TECHNICAL BULLETIN

FA-A-0427-A

Change of External Appearance of Cable Clamp

AD75CK

Change points	Before change	After change
Sticker on the side of the product		
Rating plate

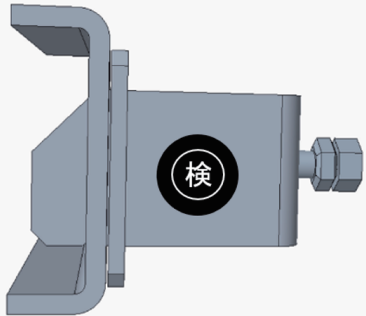
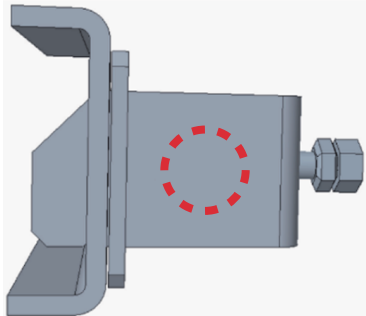
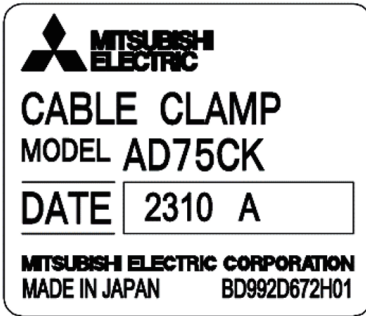
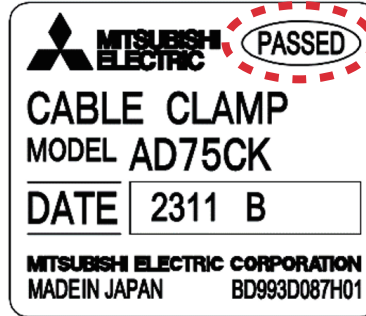
A sticker indicating inspection completion will be removed from the side of the product. Instead, the word "PASSED" will be added on the rating plate for inspection completion.
